Interim Technical Report

DIABLO CANYON UNIT 1
INDEPENDENT DESIGN VERIFICATION PROGRAM
- AUXILIARY BUILDING -

REVISION 0

Auxiliary Building Report

Figure 10
 Differences Between Walls Considered in IDVP Analysis and
 Those Shown in 1971 Blume Report
 Elevation 100'-0"

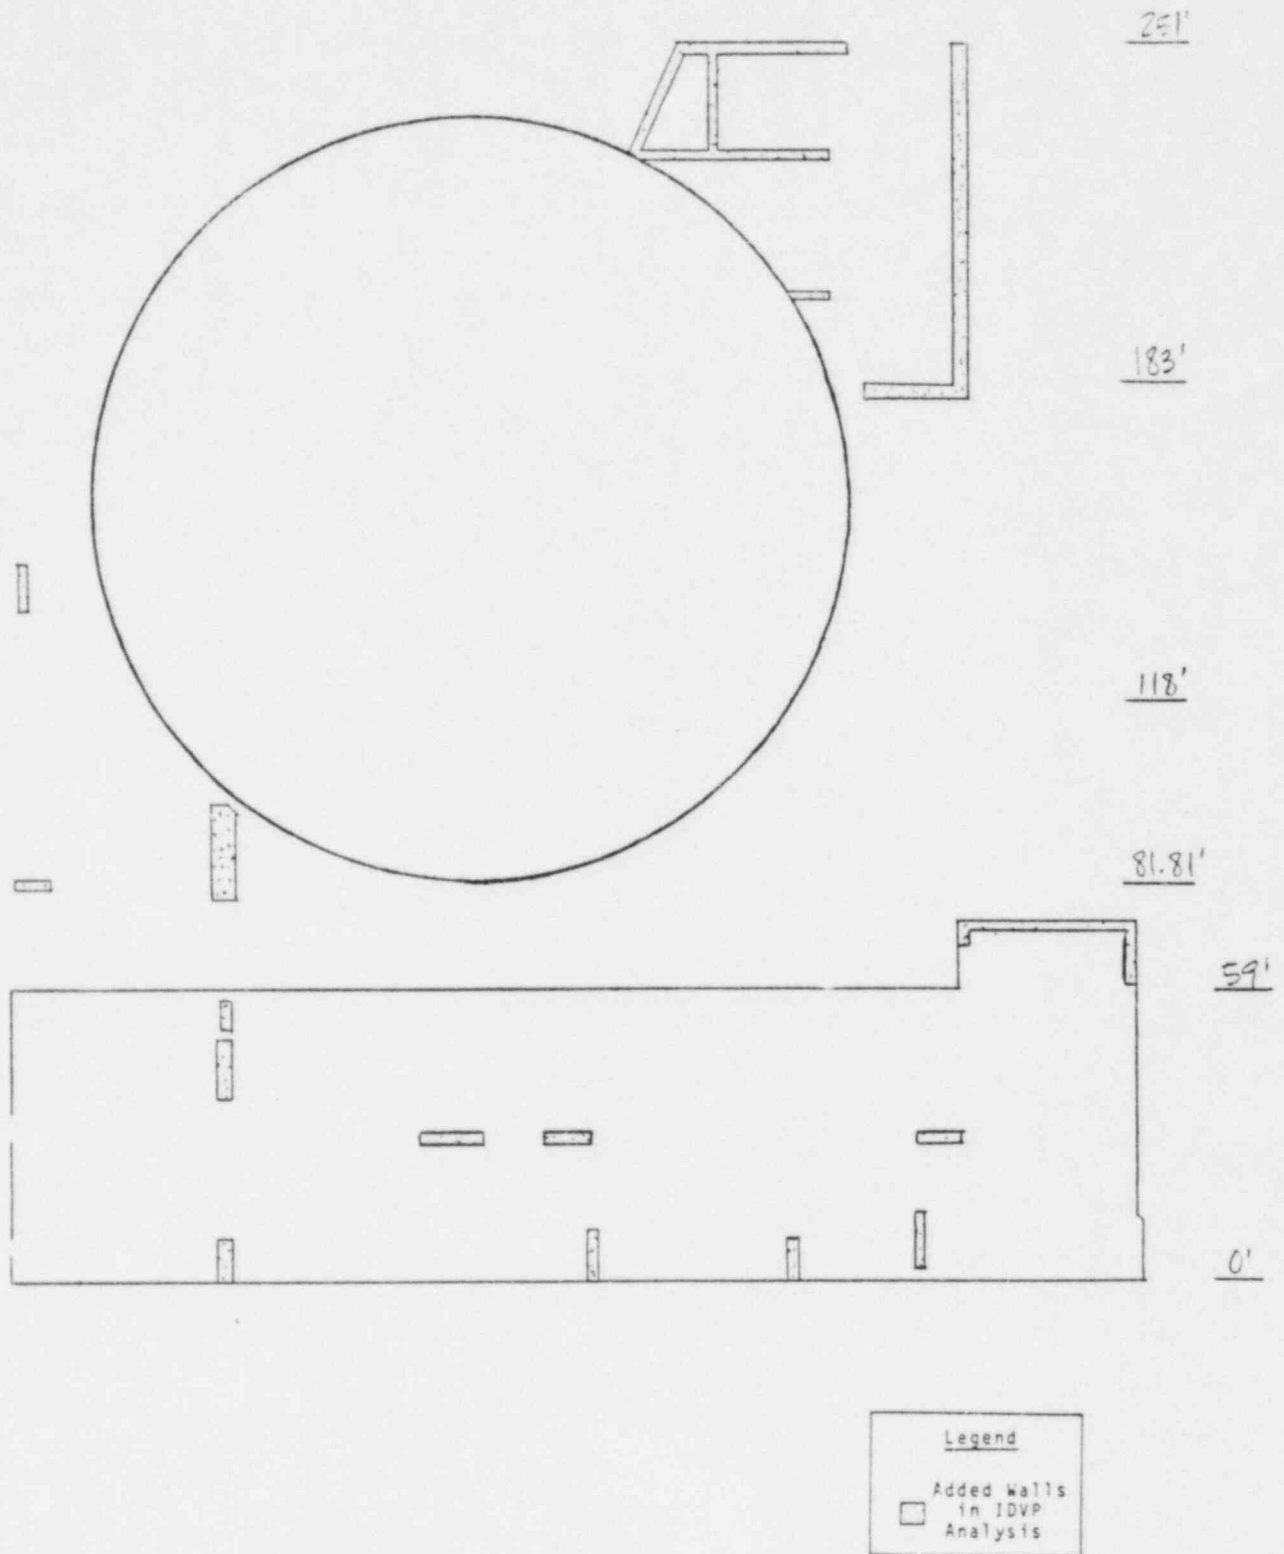
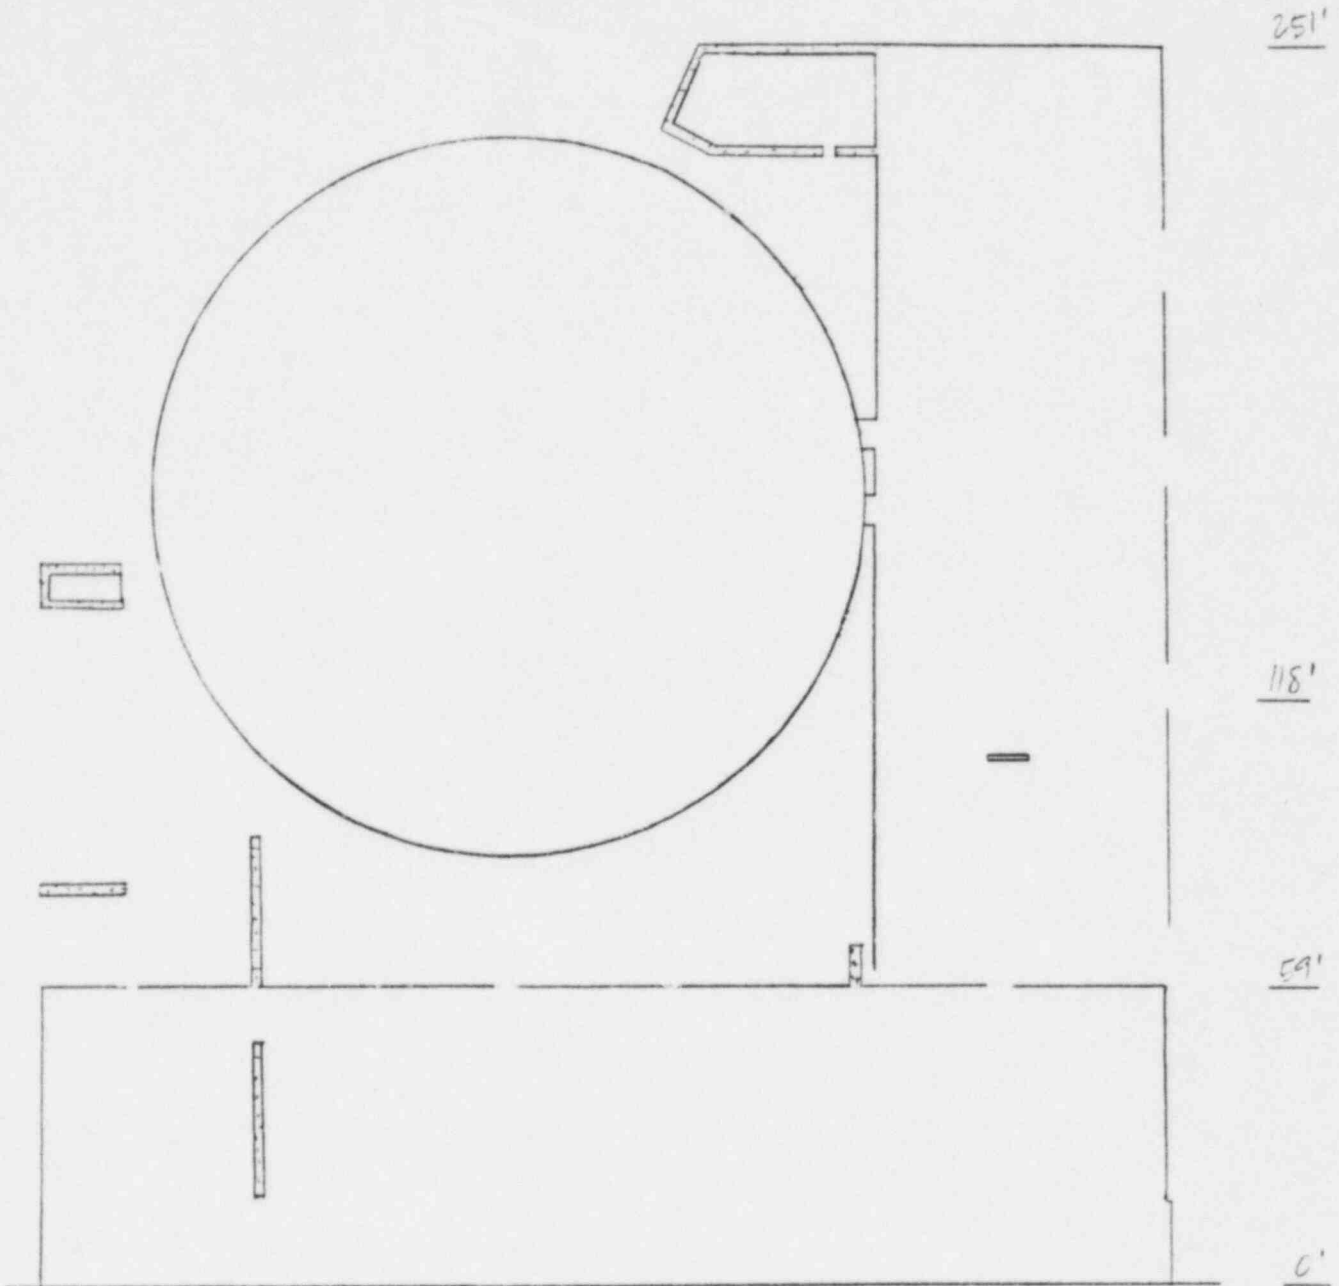
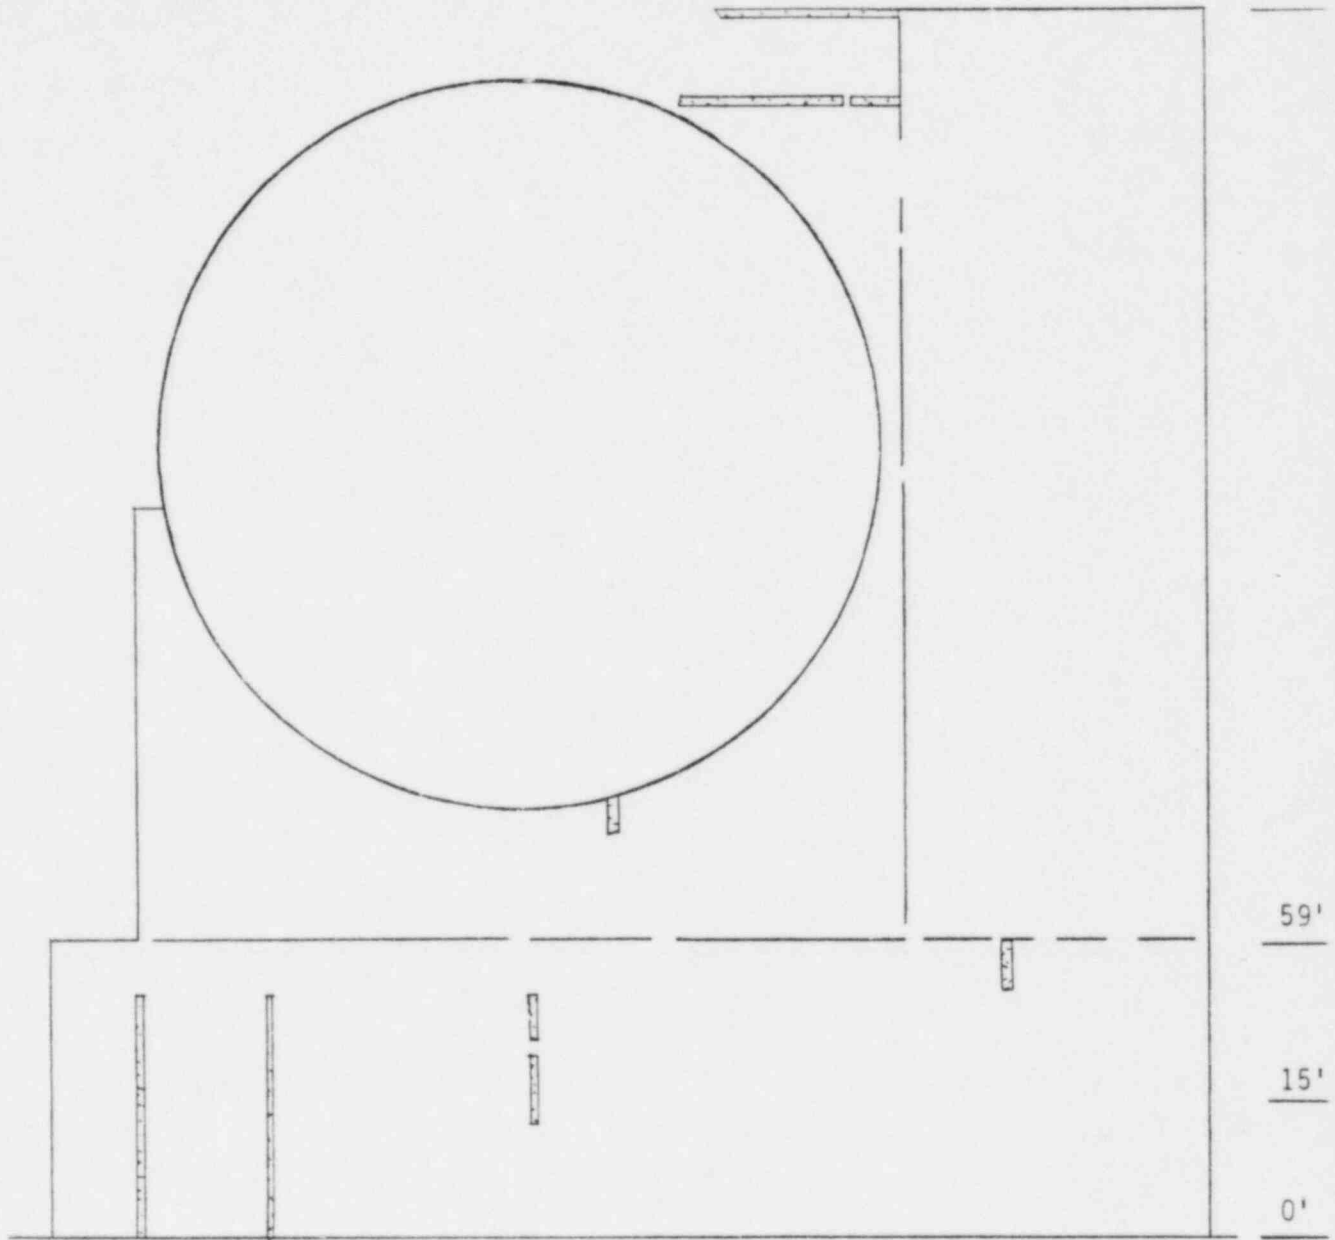
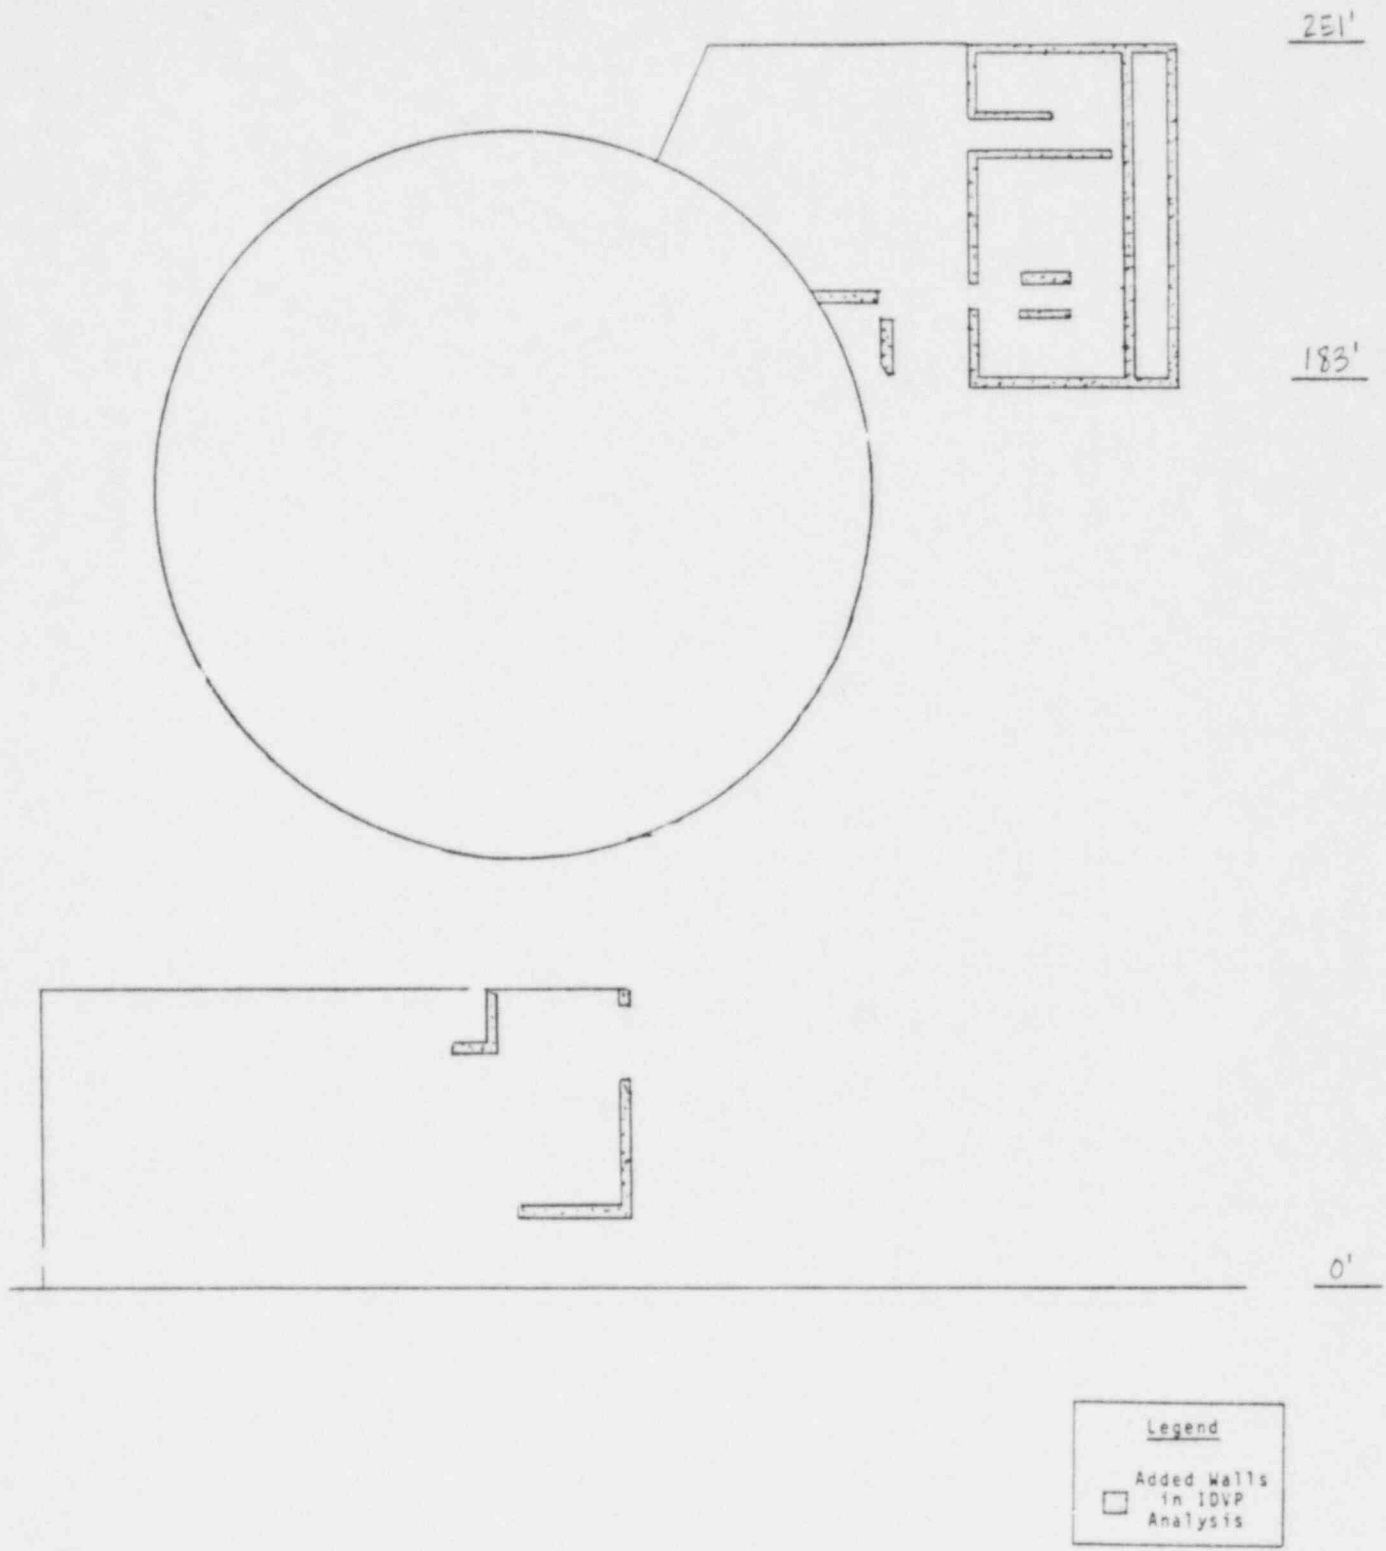
Comparisons of moments of inertia in Table 3A show large differences. The differences in values for the concrete structure as calculated in the design and verification efforts appear to be the result of a difference in methodology in the calculation of the moment of inertia for individual wall elements.

- 1) Examine the analyses of the remaining buildings to determine the procedures used to calculate moments of inertia and reconcile differences in methodology.
- 2) Review design and field changes that affect models used in the seismic qualification of the remaining safety-related structures. Field verify selected changes to ensure that "as built" configurations conform to design drawings.

Figure 16
 Comparison of Mode Shapes
 North-South Model: 5% Accidental Eccentricity to West
 Participation Factor: IDVP = 1.2%, Design = Not Available
 Mode 1

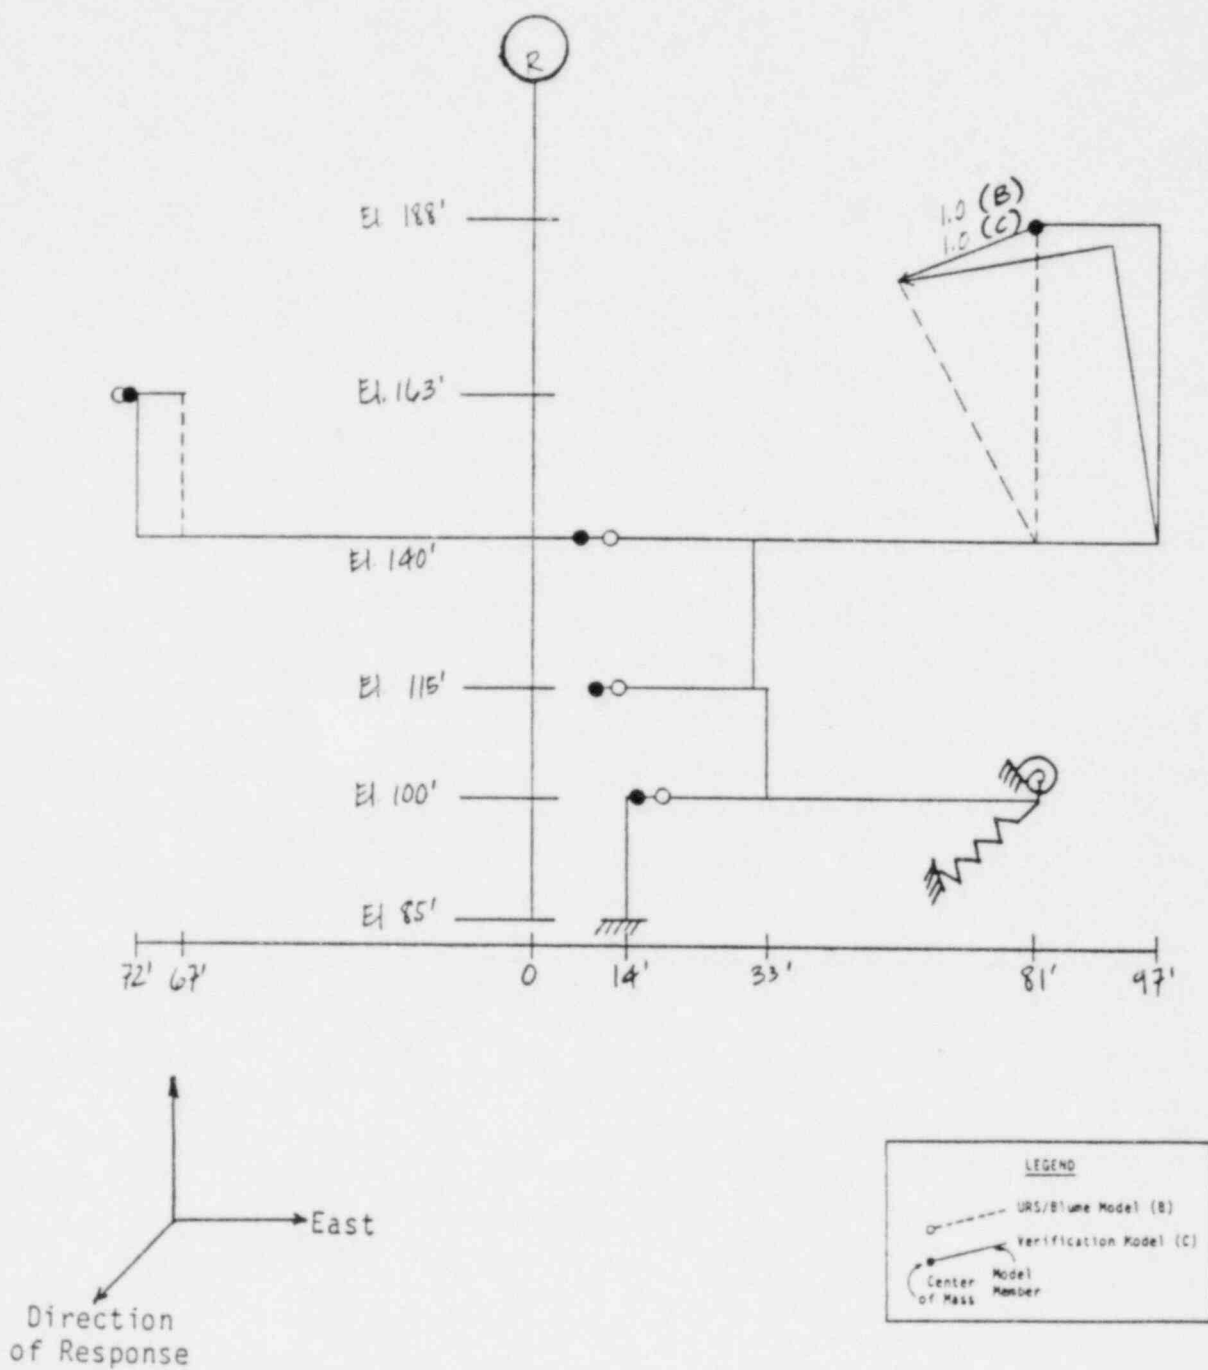
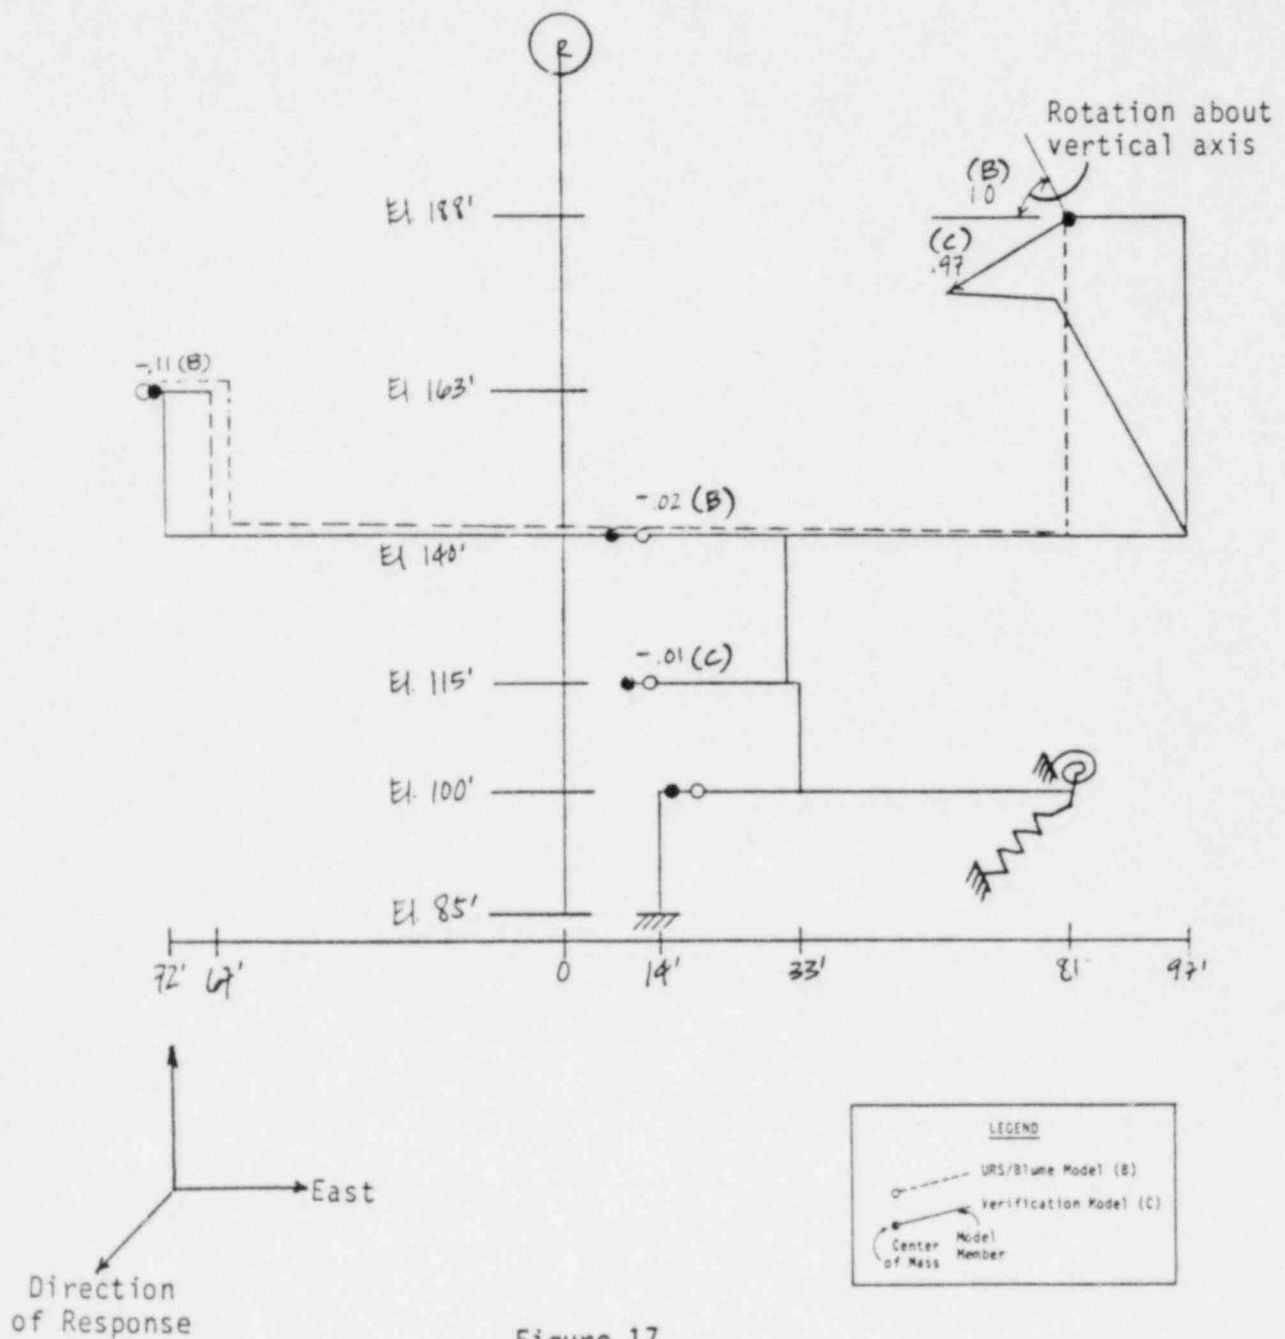
Modes 1 and 2 for the N-S 5% accidental eccentricity cases are fuel handling building translation and torsion. The verification analyses predominantly predict torsion with a small amount of translation for mode 1 whereas the design analyses predominantly predict translation. Mode 2 is translation in the verification analysis and torsion in the design analysis. Both results are consistent with the calculated torsional and translational stiffnesses for the fuel handling building. Both design and verification analyses differ in stiffness values but show close agreement in calculated mass and mass moment values.

The verification analyses show a torsional stiffness value 3.5 times lower than the design analyses, and a translational stiffness value of 1.6 times higher; this difference results in the observed transposition of translational and torsional modes between analyses.
